Re: Proposed Stream Classifications
Connecticut River Basin

Middletown Water and Sewer Comment Letter Figures

Figure No. 2 -Comments 1.a and 1.b

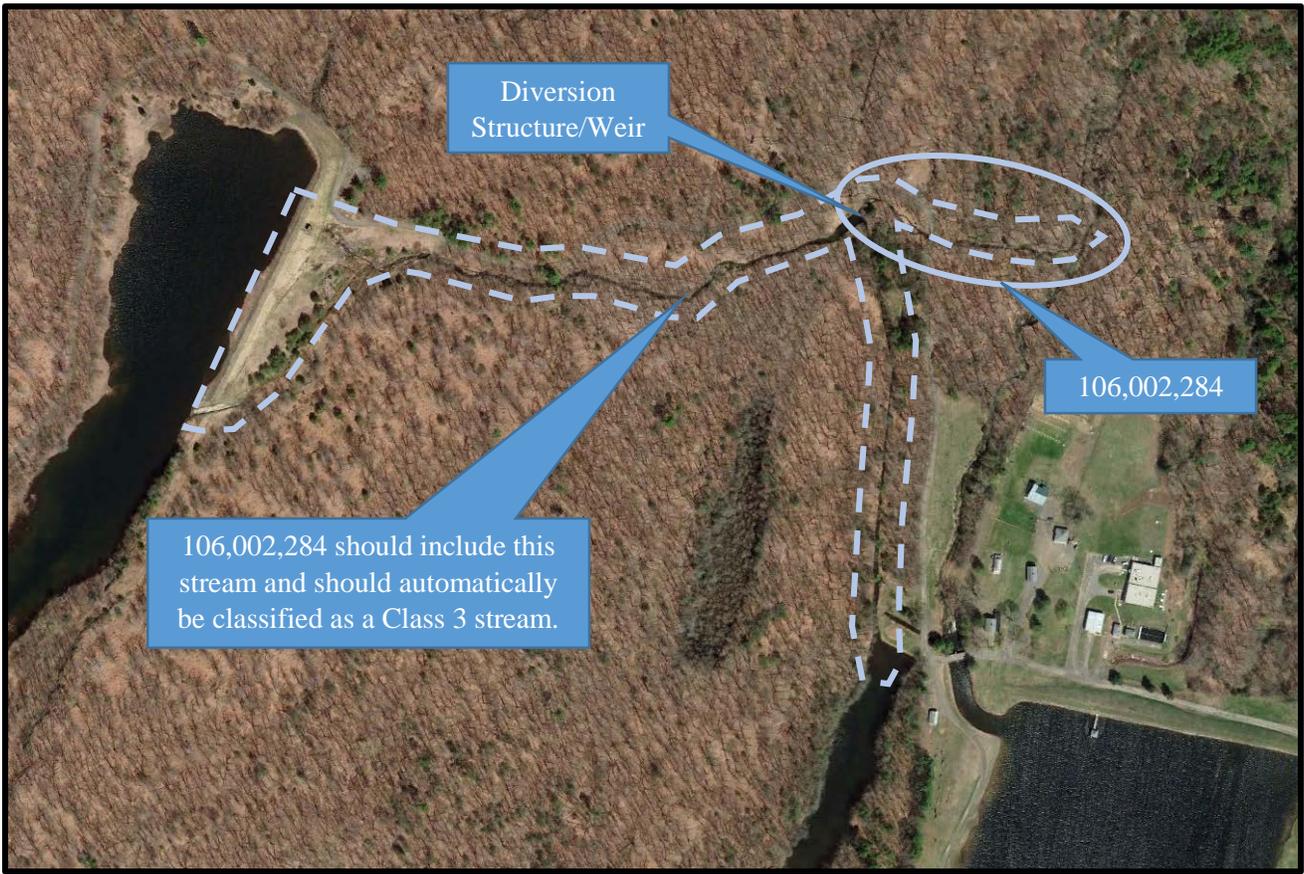
Segment	Comment
106,002,284	<p>1.a This stream segment begins at the toe of the Adder Reservoir Dam and flows towards the Higby Reservoir. It can also be diverted to Fall Brook downstream of the Higby Reservoir. The map needs to be revised to depict this segment's actual location. See Figure No. 2.</p> <p>1.b The stream segment is located immediately downstream of the Adder Reservoir Dam and should automatically be classified as a Class 3 stream. See Figure No. 2.</p>
106,002,288	<p>2. This stream segment does not receive flow from the Adder Reservoir. The map needs to be revised to depict a separation between this stream segment and the Adder Reservoir. See Figure No. 3.</p>

Figure No. 4 – Comments 3 and 4

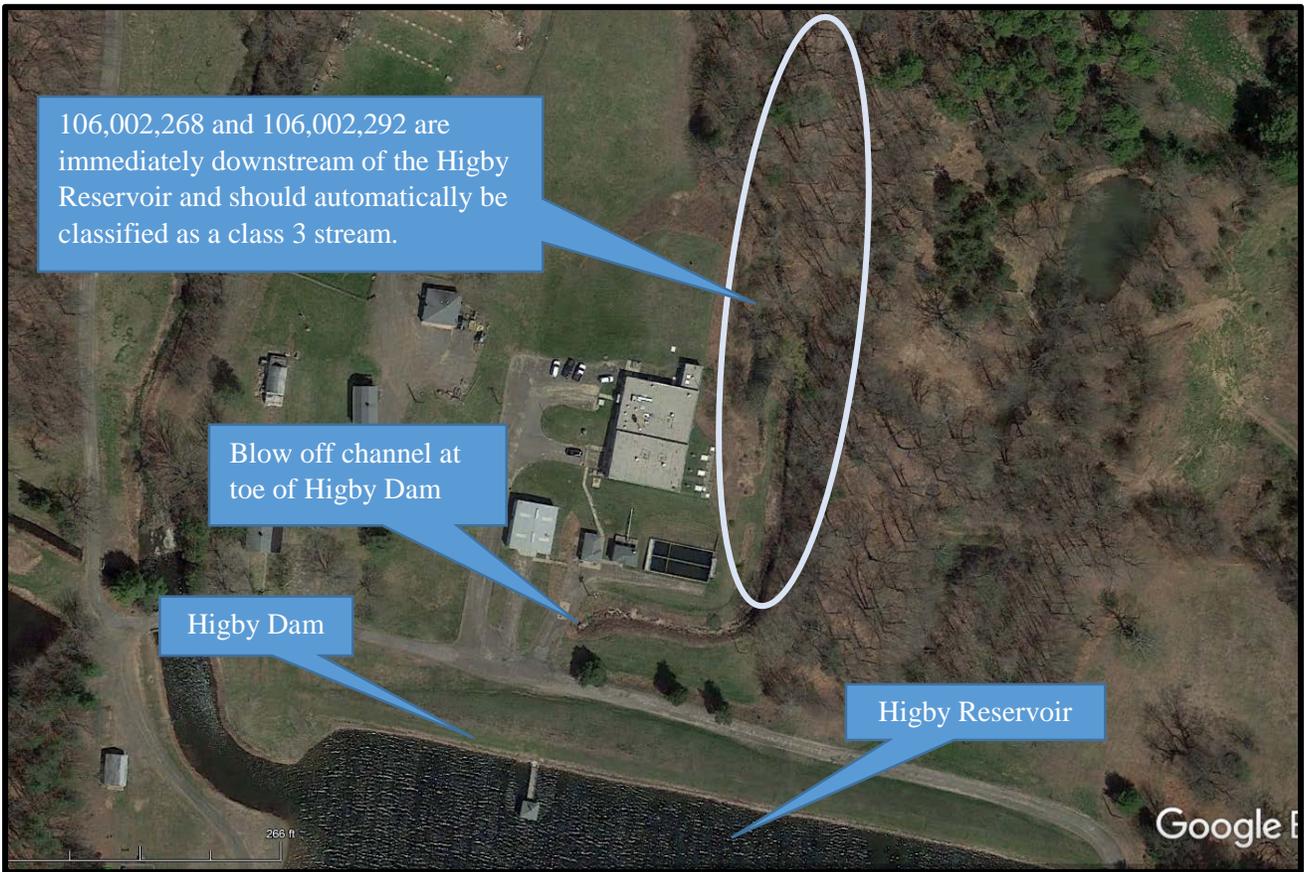
Segment	Comment (cont.)
106,002,268	3. This stream segment is located immediately downstream of the Higby Reservoir Dam. The blow offs and any leakage from the toe of the dam are directed to this segment. This segment should automatically be classified as a Class 3 stream. See Figure No. 4.
106,002,292	4. This stream segment is located immediately downstream of the Higby Reservoir Dam. The blow offs and any leakage from the toe of the dam are directed through this segment. This segment should automatically be classified as a Class 3 stream. See Figure No. 4.
106,002,158	5. This stream segment lies within the reservoir and connects Higby Reservoir No. 3, Higby Reservoir No. 2 and Higby Reservoir No. 1. This segment flows through a culvert under CT Route 66 between Reservoirs No. 3 and No. 2; and flows through a cast iron pipe through an earthen dike between Reservoirs No. 2 and No. 1. This segment flows through man made conduits between reservoirs and should be classified as a Class 4 stream or deleted since it is within the reservoir.

106,002,268 and 106,002,292 are immediately downstream of the Higby Reservoir and should automatically be classified as a class 3 stream.
